Well Name: COVINGTON A FEDERAL	Well Location: T22S / R32E / SEC 25 / SESE / 32.357325 / -103.621984	County or Parish/State: LEA / NM
Well Number: 11	Type of Well: OIL WELL	Allottee or Tribe Name:
Lease Number: NMNM2379	Unit or CA Name:	Unit or CA Number:
US Well Number: 3002533074	Operator: OXY USA INCORPORATED

Type of Submission: Notice of Intent Type of Action: Plug and Abandonment

NOI TO PERMANENTLY ABANDON THIS WELL VIA CEMENT PLUGGING.

REVISED

Proposed Wellbore

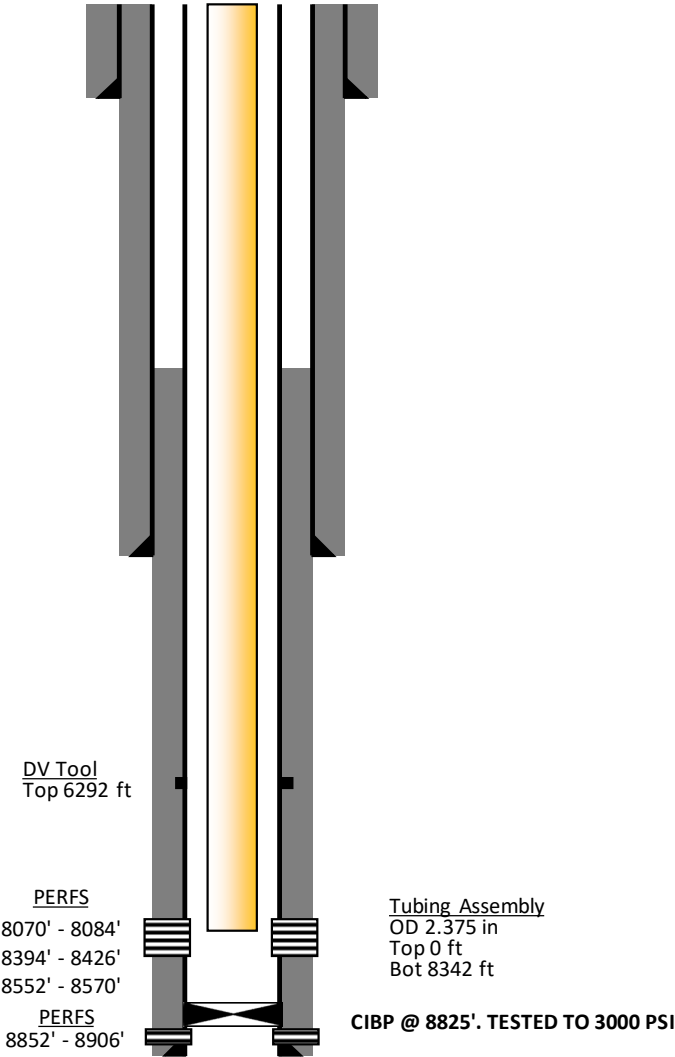
PERF AND SQUEEZE 240 SX CMT FROM 1000' TO SURF
 VERIFY CMT TO SURFACE

SPOT 20 SX CMT FROM 8825' TO 8570'
 CIBP @ 8825'. TESTED TO 3000 PSI

Proposed Wellbore
COVINGTON A FEDERAL 011

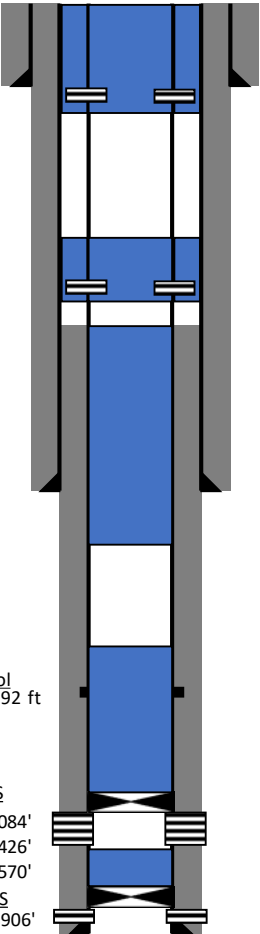
PERF AND Circulate 266 SX CMT FROM 1447' TO SURF
VERIFY CMT TO SURFACE

*Run CBL from CIBP to surface.

Submit results to BLM.

SPOT 25 SX CMT FROM 8825' TO 8570' WOC and Tag.
CIBP @ 8825'. TESTED TO 3000 PSI

1. POOH WITH EXISTING 2-3/8" TBG AND BHA
2. RIH AND TAG EXISTING CIBP @ 8825'
3. SPOT 25 SX CL H CMT FROM 8825' TO 8570' WOC and Tag
4. SET CIBP AT 8020' VIA WORKSTRING. LEAK TEST TO 500 PSI FOR 30 MINUTES
5. RUN CBL FROM CIBP SET AT 8020' TO SURFACE PER OCD REQUIREMENTS. REVIEW WITH BLM.
6. SPOT 180 SX CMT (139 SX CL C AND 41 SX CL H CMT) FROM 8020' TO 5750'. WOC AND TAG
7. SPOT 153 SX CL C CMT FROM 5050' TO 3110'. WOC AND TAG
8. PERF AND SQUEEZE 72 SX CL C CMT 3000' TO 2700'. WOC AND TAG
9. PERF AND Circulate 266 SX CL C CMT FROM 1447' TO SURFACE
10. VERIFY CMT TO SURFACE
